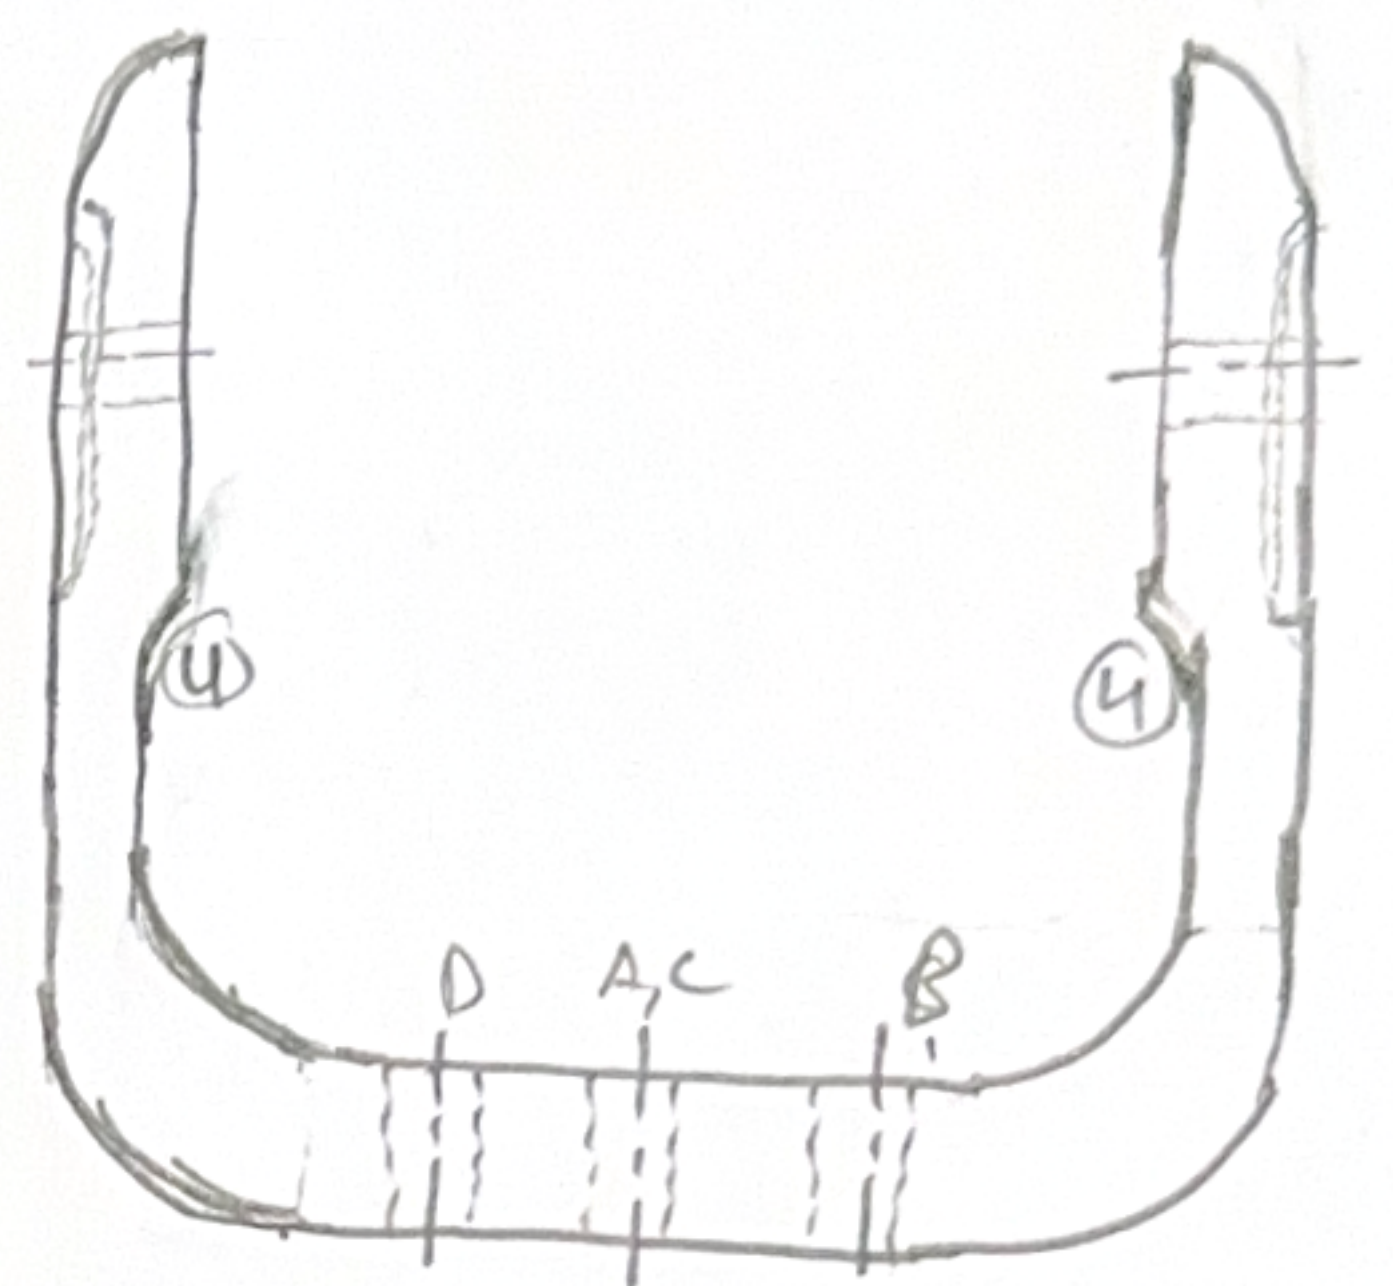
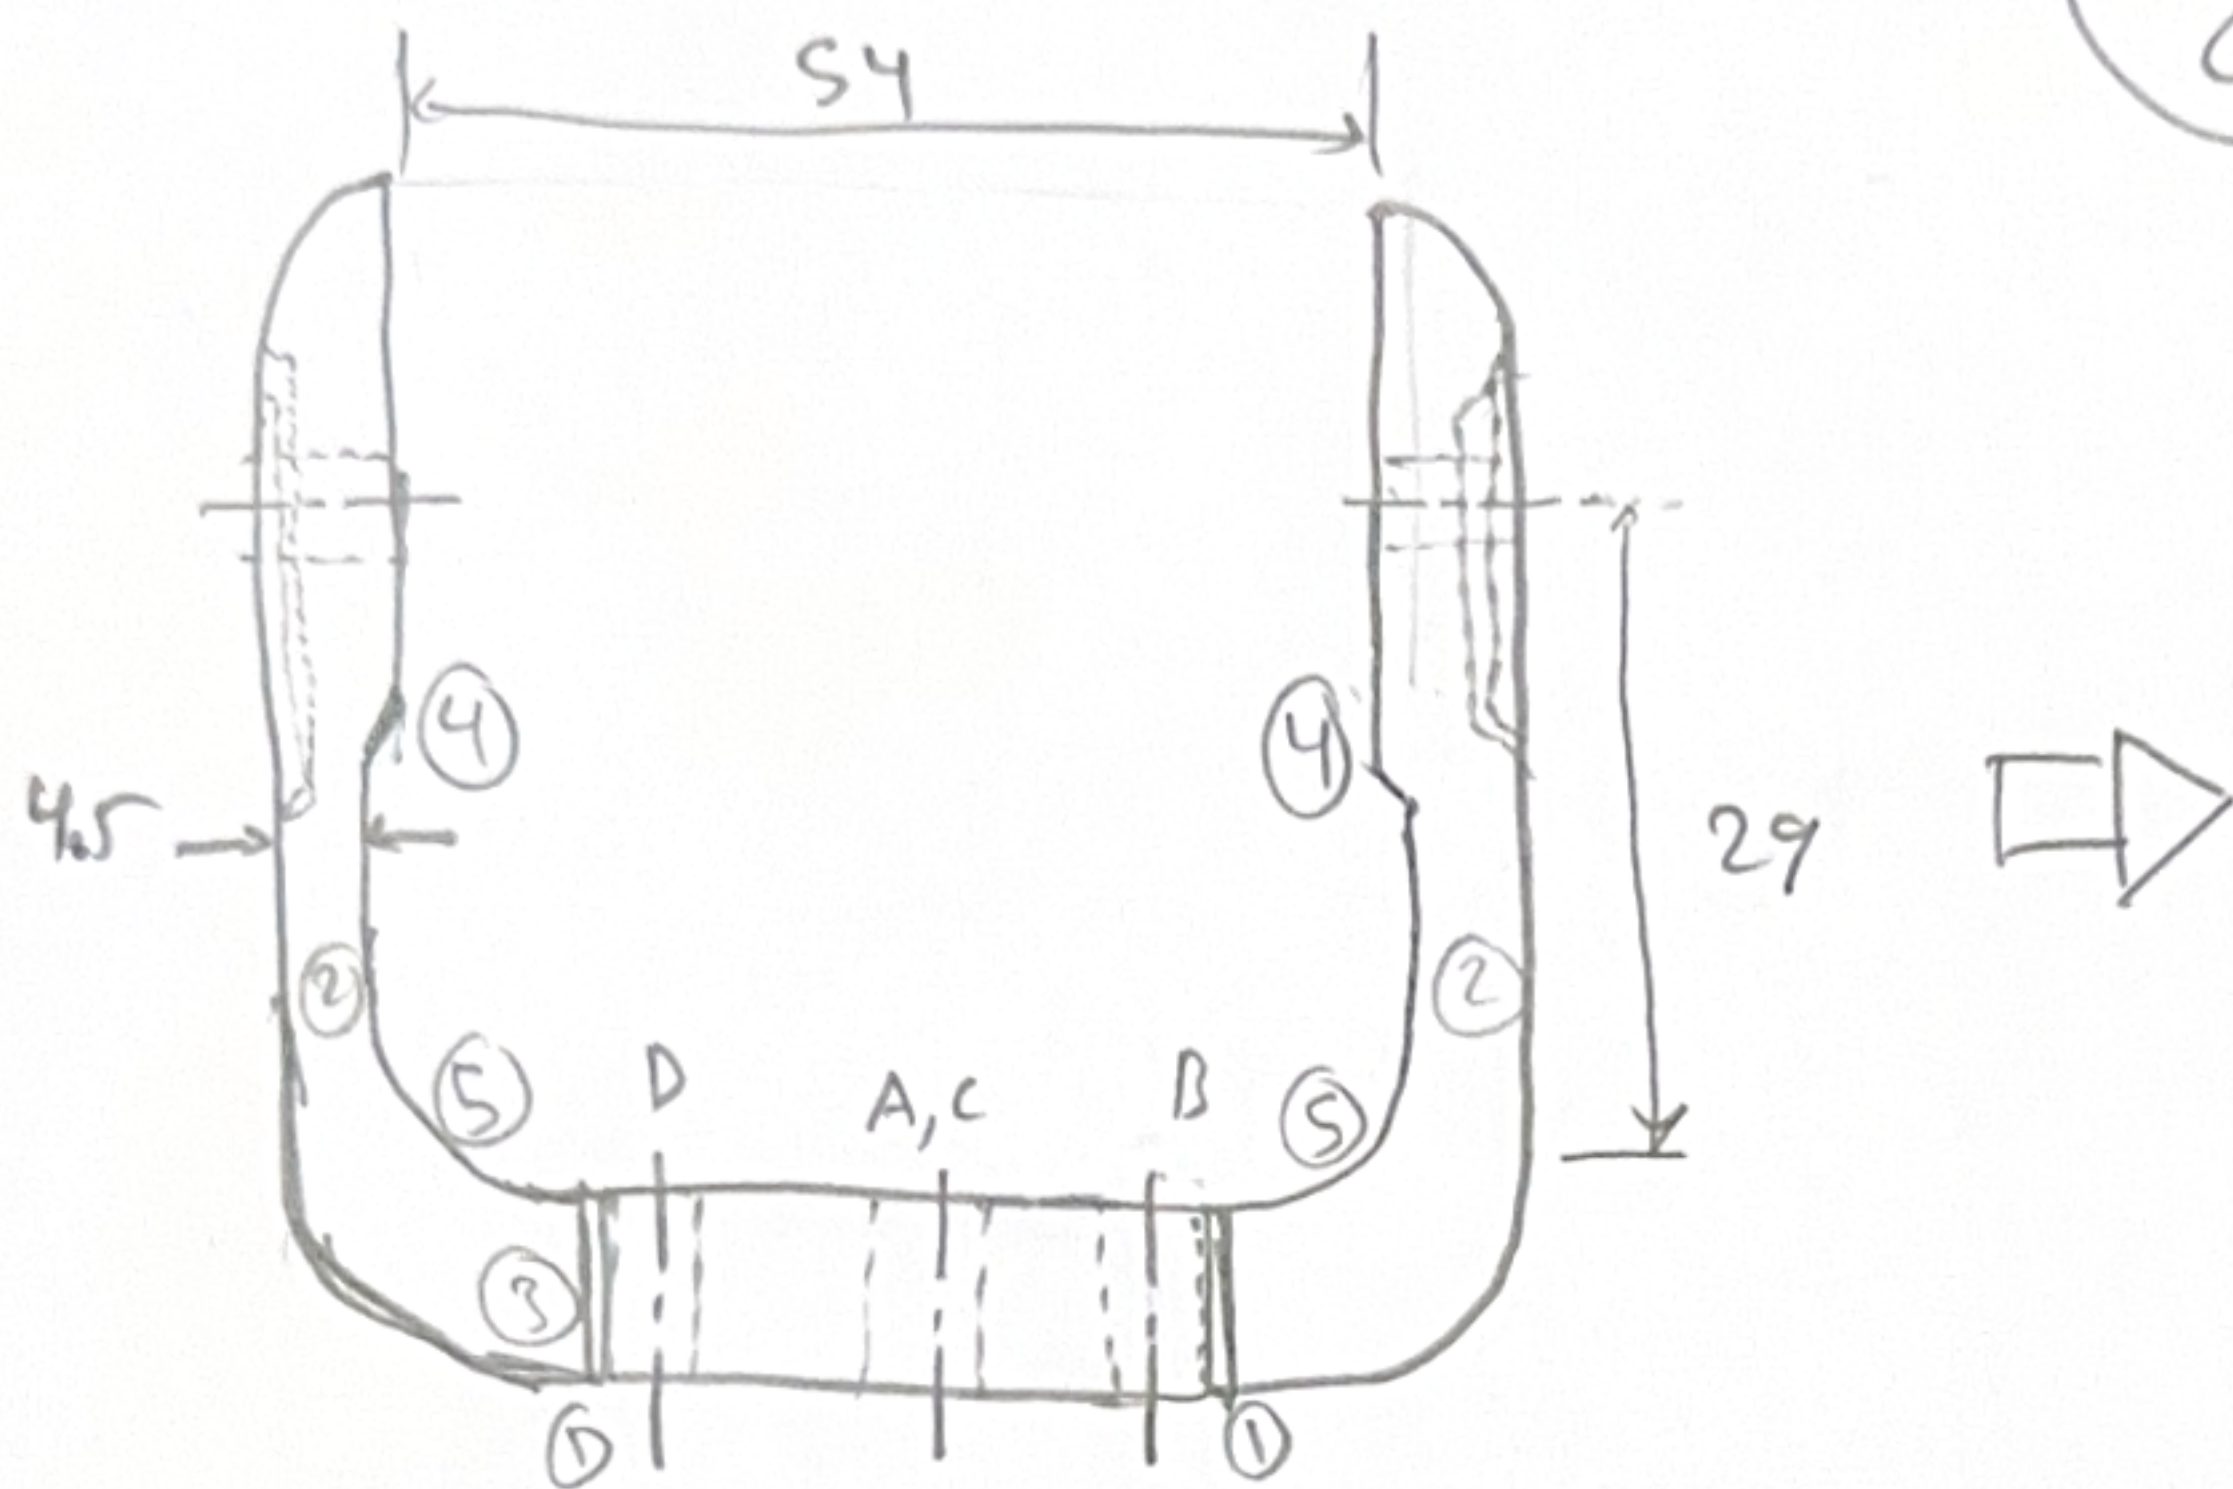
- ④ Remove the chamber at ④ and replace it with fillet to reduce stress.
- ⑤ B&D were moved away from the fillet ⑤ to avoid failures due to tensile stress and less than adequate <sup>bolt</sup> torque.
